**ZONING AMENDMENT,
PLANNED UNIT DEVELOPMENT &
SUBDIVISION STAFF REPORT**

<u>NAME</u>	Douglas Roy Parker, III
<u>SUBDIVISION NAME</u>	South Jones Subdivision
<u>LOCATION</u>	1926 & 2000 Telegraph Road (Southeast corner of Telegraph Road and New Bay Bridge Road.)
<u>CITY COUNCIL DISTRICT</u>	District 2
<u>PRESENT ZONING</u>	B-2, Neighborhood Business District, and I-1 Light Industry District
<u>PROPOSED ZONING</u>	I-1, Light Industry District
<u>REASON FOR REZONING</u>	To eliminate split zoning to allow the expansion of a welding shop in phases.
<u>AREA OF PROPERTY</u>	2 Lots / 3.4 Acres ±
<u>CONTEMPLATED USE</u>	<p>Subdivision approval to create 2 legal lots of record, Planned Unit Development Approval to allow multiple buildings on a single building site as well as shared access and parking between two building sites, and Rezoning from B-2, Neighborhood Business District, and I-1 Light Industry District, to I-1, Light Industry District, to eliminate split zoning and allow for the expansion of a welding shop in phases.</p> <p>It should be noted, however, that any use permitted in the proposed district would be allowed at this location if the zoning is changed. Furthermore, the Pla

SITE PLAN

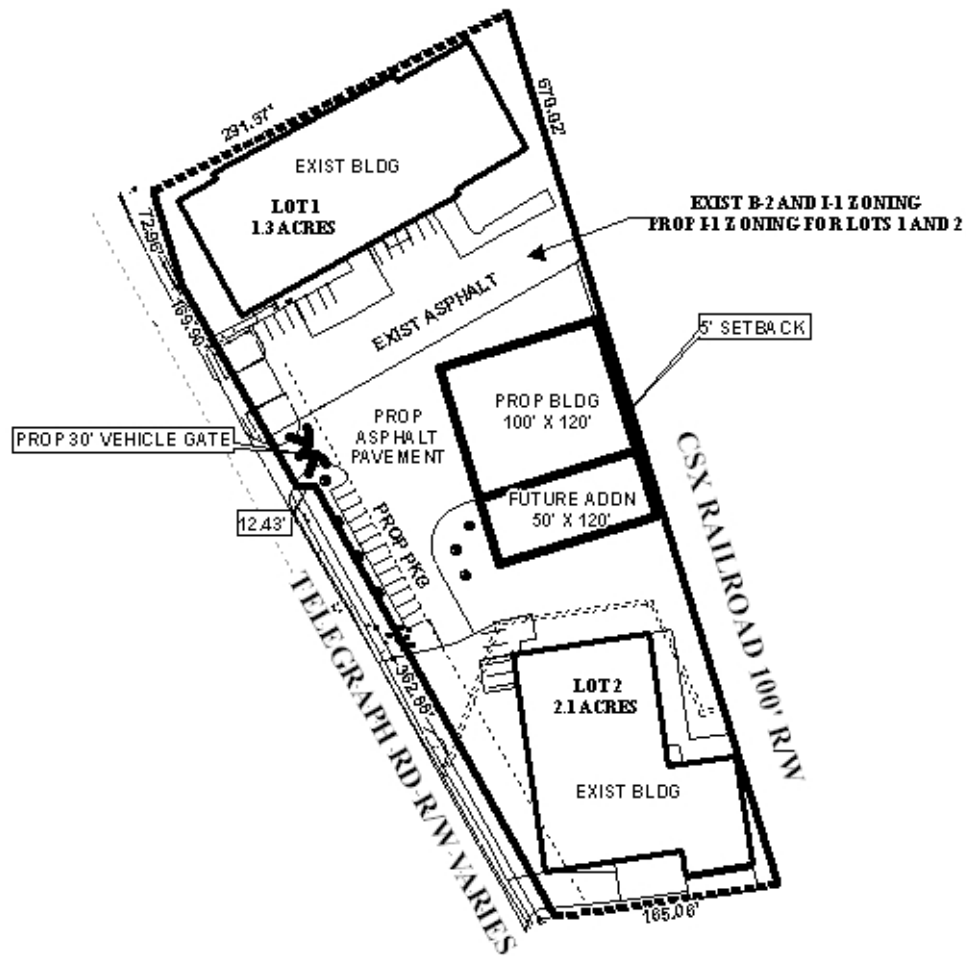
There are several deficiencies with the site plan that has been submitted. Regarding the existing development on the site, the site plan does not appear to depict the entirety of the paved area for maneuvering on the site. The site plan should be revised to depict all areas which are paved, or proposed to be paved. The site plan indicates existing and proposed curb cuts, including the large, continuous curb cut at 1926 Telegraph Road. Also indicated is a new vehicle gate at the proposed new curb cut. The site plan does not indicate whether the gate also includes a fence, and whether or not any of the other curb cuts will be gated. Additionally, gated access requires 51 feet of queuing area for vehicle stack-up. The site plan should be revised to address these issues.

Regarding the Southernmost two curb cuts, one is approximately 55 feet wide and the other is approximately 130 feet wide with only a small 30-foot wide break between them. It should be noted that it appears that this situation developed without benefit of approvals, and required landscaping was removed improperly. This situation should be remedied reducing the curb cuts to two standard 24-foot width cuts. Also, as mentioned previously, information should be provided to indicate whether or not these curb cuts will be gated.

The site plan contradicts itself regarding parking. The site plan indicates that 17 parking spaces will be provided, however, 32 parking spaces are depicted. This discrepancy should be corrected, and all parking spaces that will remain should be indicated as such on the site plan.

Dumpsters are not indicated on the site plan. The location of all dumpsters, with dumpster/recycle pads, appropriate enclosures, and appropriate amenity hookups should be depicted on the site plan. Any fencing on the site, regardless of type, should be indicated.

As mentioned earlier, it appears that landscaping area and tree plantings were improperly removed on the southernmost portion of the site. This situation should be resolved by bringing that portion of the site back into compliance. The new building area must meet full compliance with landscaping area and tree planting requirements of the ordinance as it represents at least a 50% expansion. Additionally, it has been the policy of the Commission to require full compliance with landscaping areas and tree plantings for the entire site that is included in the PUD. Since the two building sites will essentially function as one, full compliance for both sites should be required, and the site plan should be revised to indicate this.

As Telegraph Road is a planned major street, access management is a concern. The PUD proposes four curb cuts for the site, including the previously mentions 55-foot and 130-foot wide curb cuts. Given the proposed layout of the site, two curb cuts for the entire site should be sufficient. As the site will function as a PUD, the curb cuts should not be limited to specific lots, but shared between the two lots. The size, design, and exact location of all curb cuts are to be approved by Traffic Engineering and conform to AASHTO standards.

- 1) depict the entirety of the paved area for maneuvering on the site, including the boundaries of all paved areas;
- 2) revise the site plan to depict location of all proposed fencing and gates;

- 3) where gates will be installed at curb cuts, indicate 51 feet of queuing space between the right-of-way and the gate;
- 4) revise the site plan to indicate two shared curb cuts to the site with the size, location, and design to be approved by Traffic Engineering and conform to AASHTO standards;

- 5) revise the parking data to match what is shown on the site plan;
- 6) clearly indicate parking areas, number of spaces, and maneuvering areas;
- 7) indicate location of dumpsters on the site with appropriate dumpster pads and enclosures;

- 8) indicate full compliance for the entire site with tree planting and landscaping area requirements for the entire site; and
- 9) revise the site plan as appropriate to account for dedications which may be required by the subdivision application.
